ADDENDUM NO. 2

WASHINGTON STATE PARKS AND RECREATION COMMISSION LEWIS AND CLARK TRAIL STATE PARK COMFORT STATION RENOVATION EW-C6530

DATE: December 9, 2024

SHEET 15 OF 17

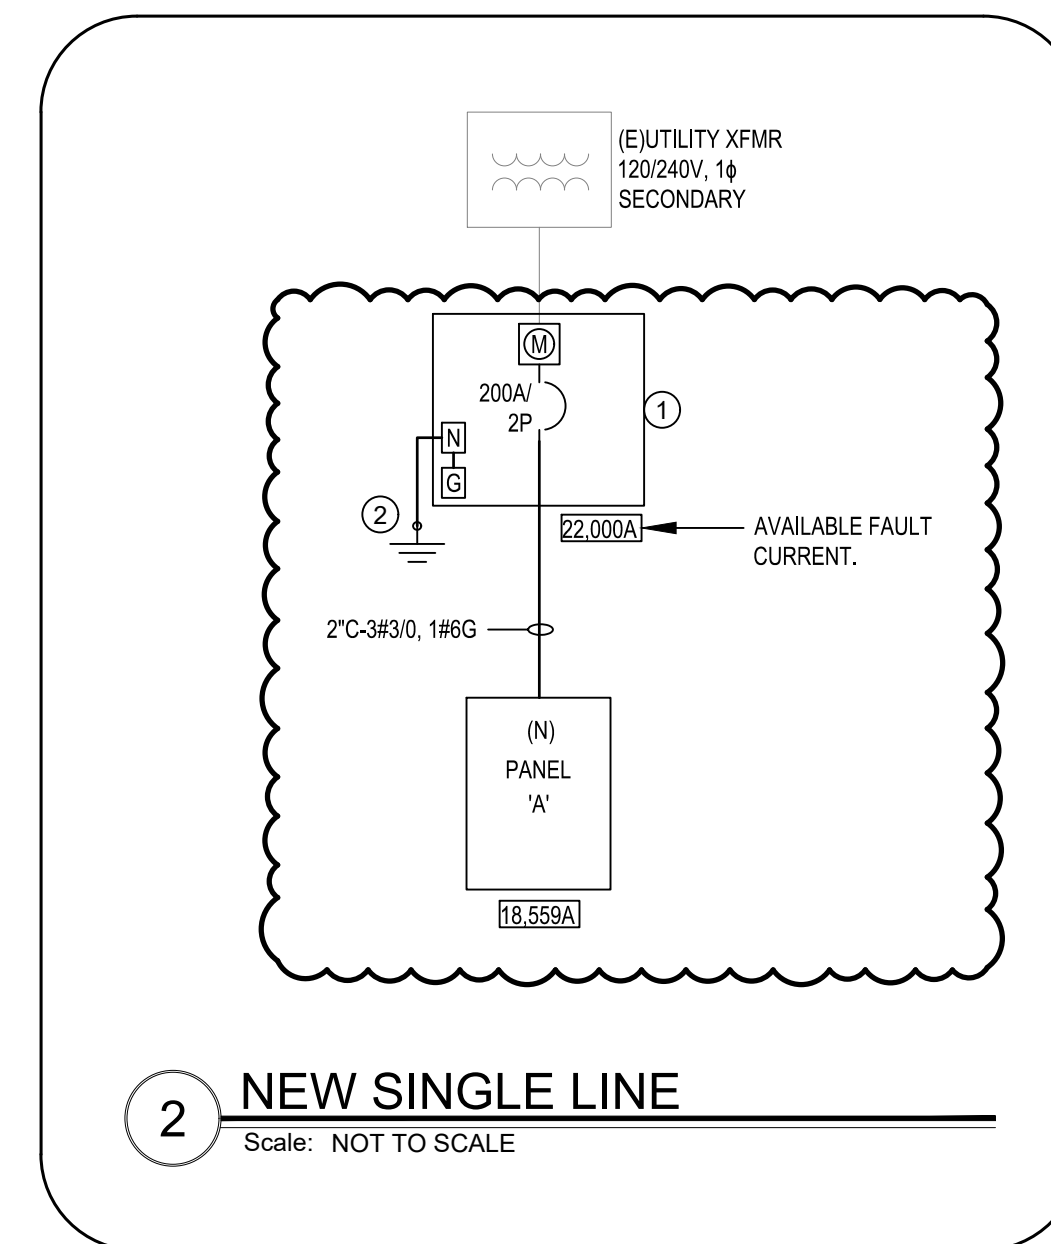
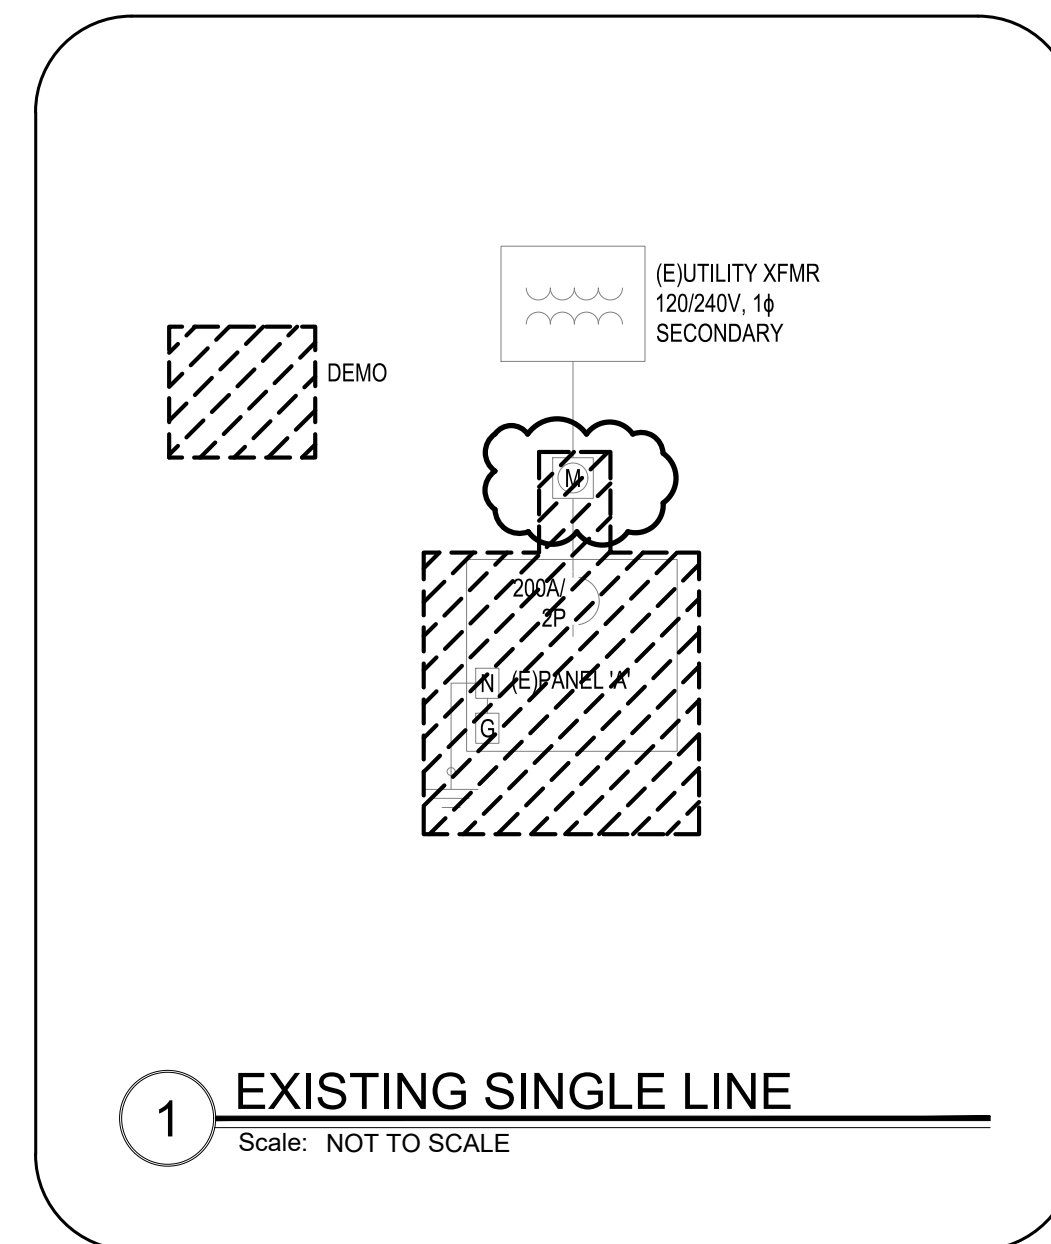
REVISION: Electrical service and electrical panel shall be revised as defined in the attached revised Sheet 15 of 17.

- Updated panel schedule "E" note.
- Removed main breaker from panel 'A'.
- Indicated existing meter to be removed and replaced in place with new Meter/Main.
- Updated new single line to account for new Meter/Main and new panel 'A' location.
- Updated keynotes

SHEET 17 OF 17

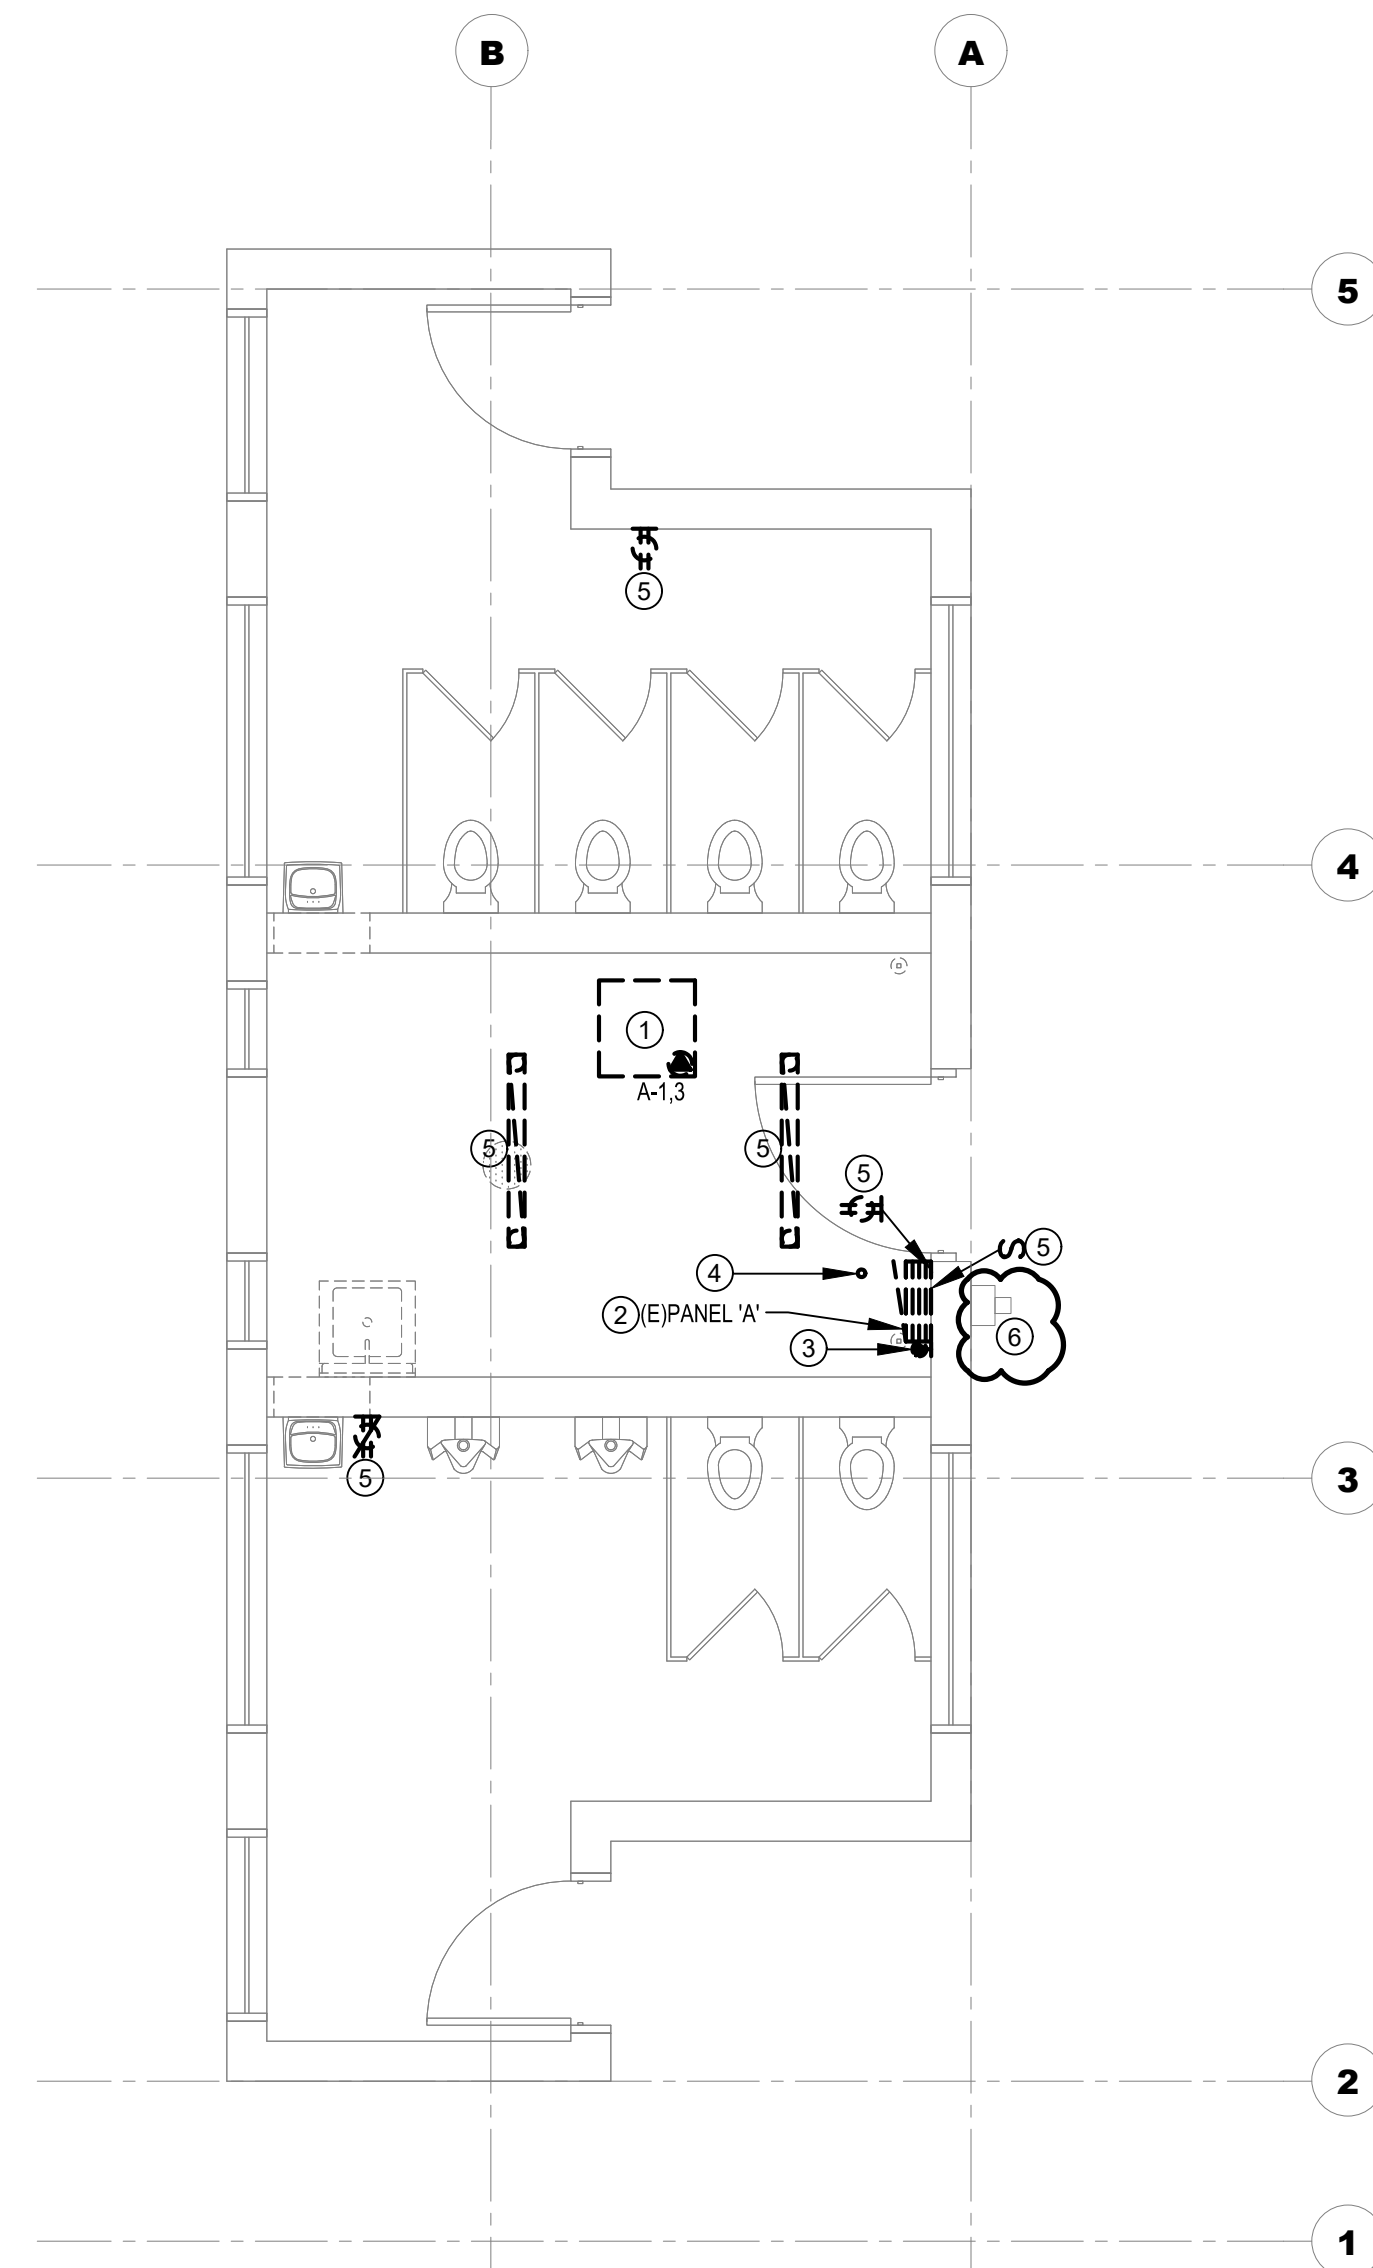
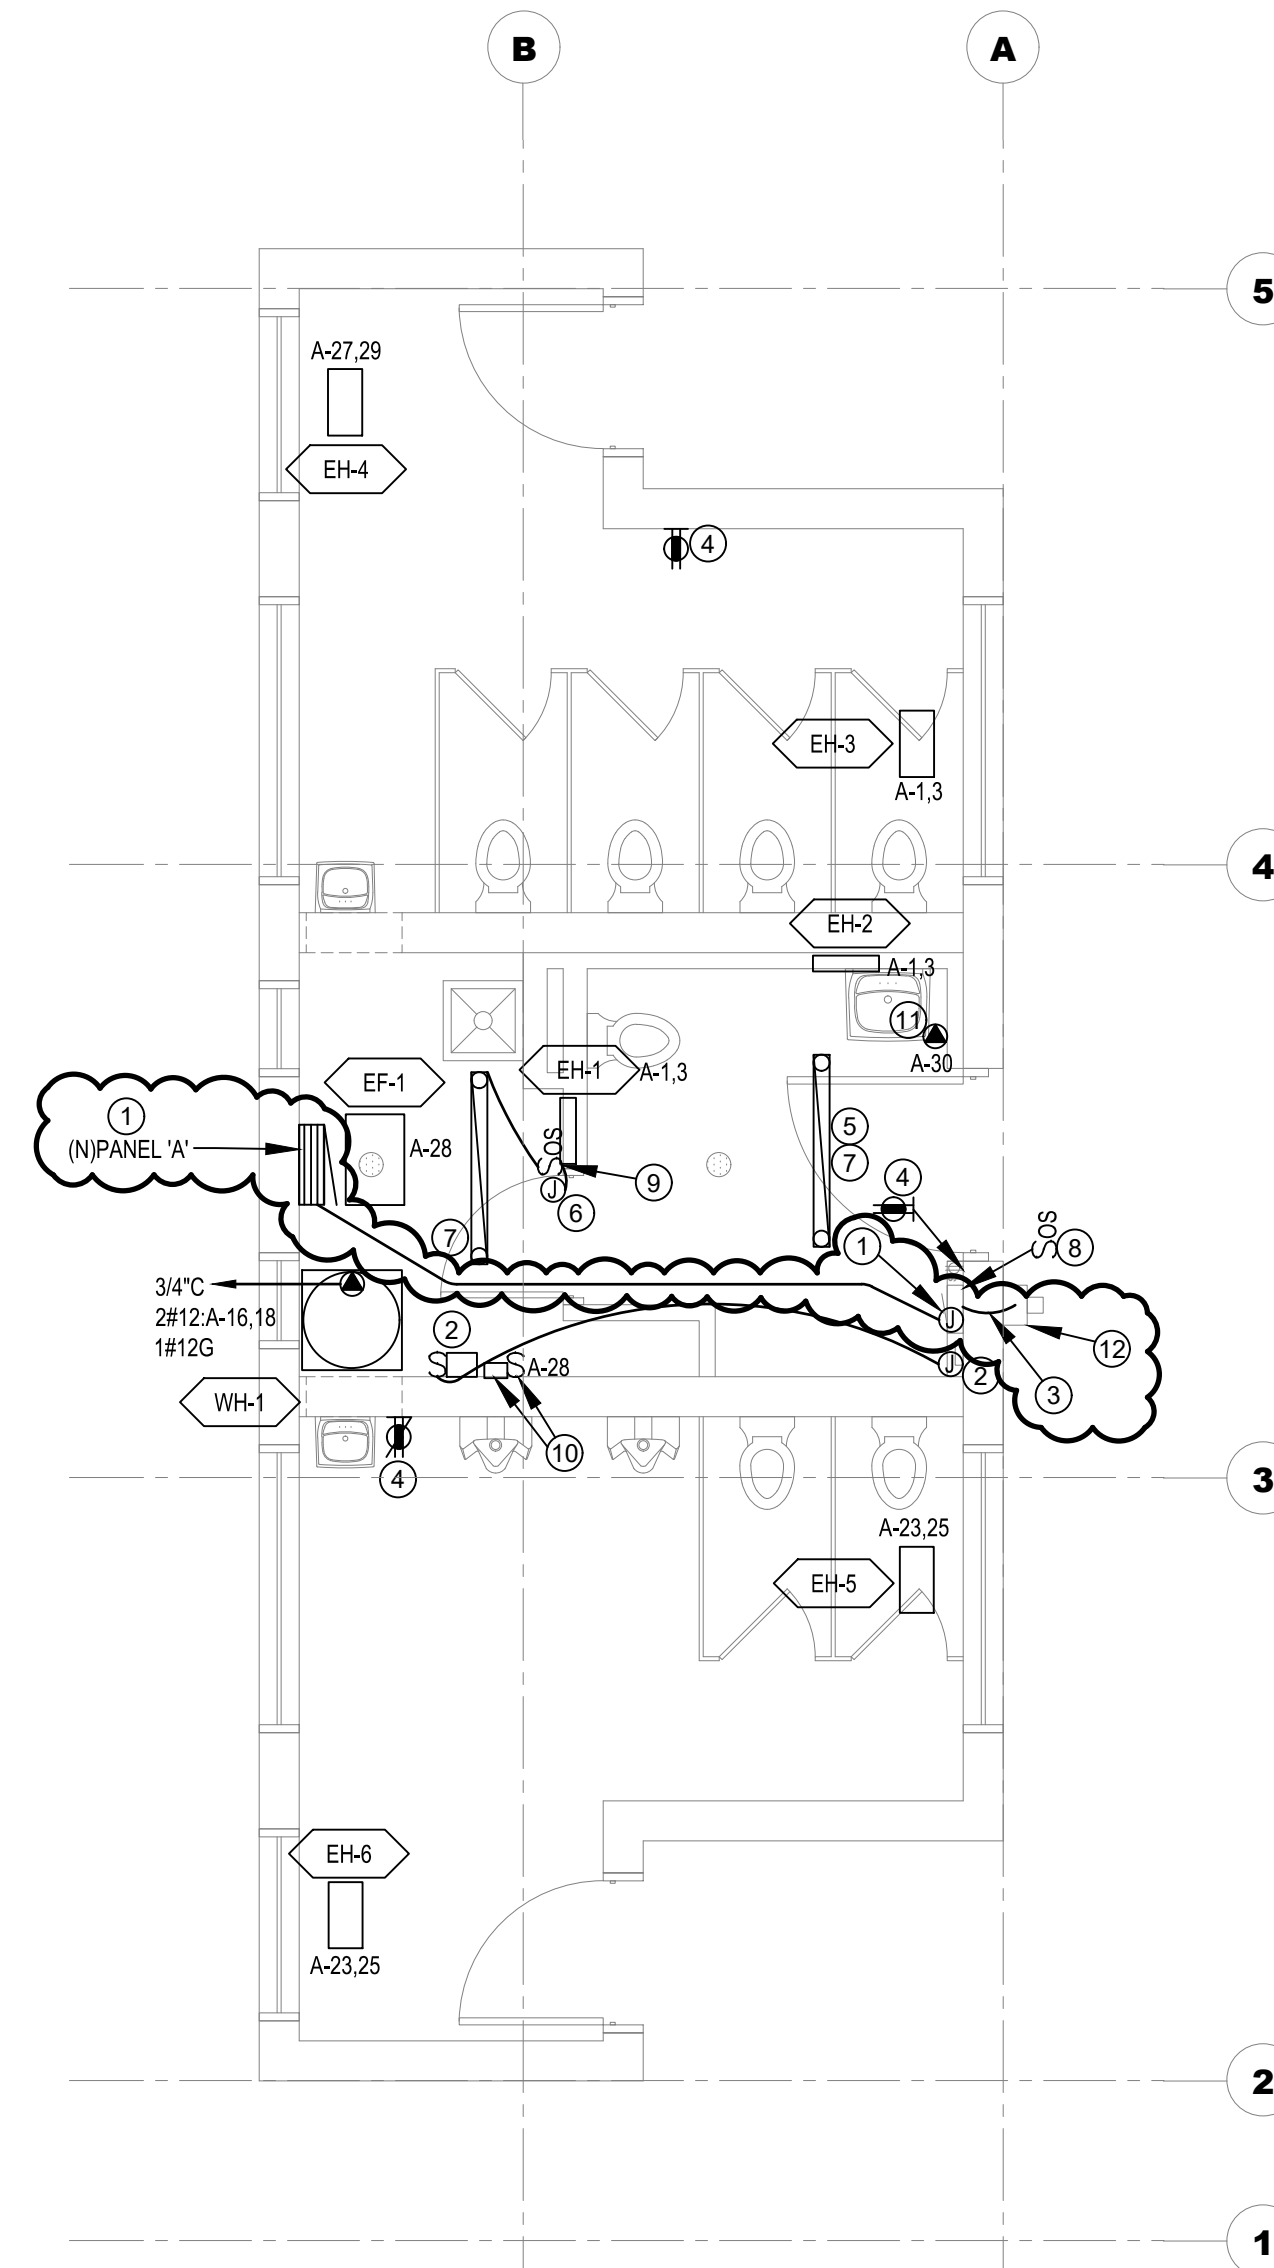
REVISION: Electrical service and electrical panel shall be revised as defined in the attached revised Sheet 17 of 17.

- Indicated existing meter to be removed and replaced in place with new Meter/Main.
- Moved new panel 'A' to Maintenance room.
- Indicated for all existing to remain circuit(s) to be extended from to be demolished panel 'A' location to new panel 'A' location.
- Updated keynotes.
